Planning Proposal to Rezone 44 Middle Arm Road, Goulburn to R2 Low Density Residential and RE1 Public Recreation (REZ/0001/2324)(PP_2023_1505).

ATTACHMENT 1 - DETAIL

Map 1. SLWCA Map for Residential Sewered Development.

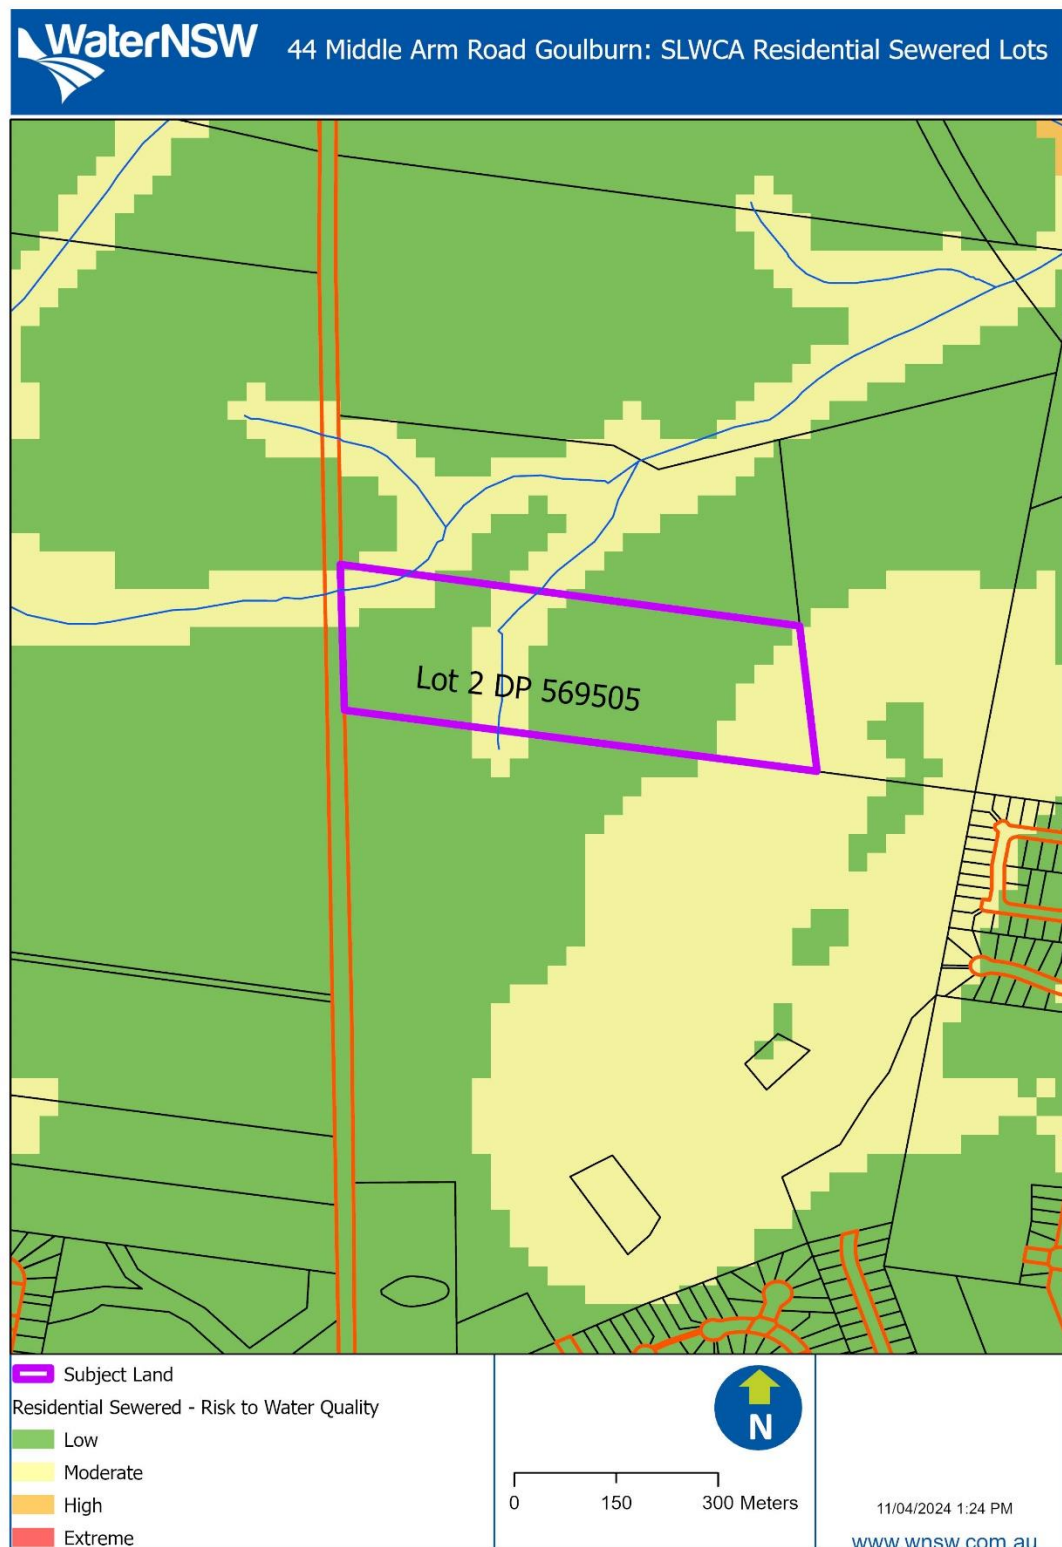
The SLWCA shows that the water quality risks varies from LOW to MODERATE, with the MODERATE risk being associated with the two drainage features and land in the south-east of the site. The areas of MODERATE risk associated with the drainage features generally accord with the proposed location of the RE1 zones. Areas of LOW risk have a HIGH capability for the intended land use while areas of MODERATE risk have a MODERATE capability. Please note that the SLWCA does not consider or take into account flooding risk.
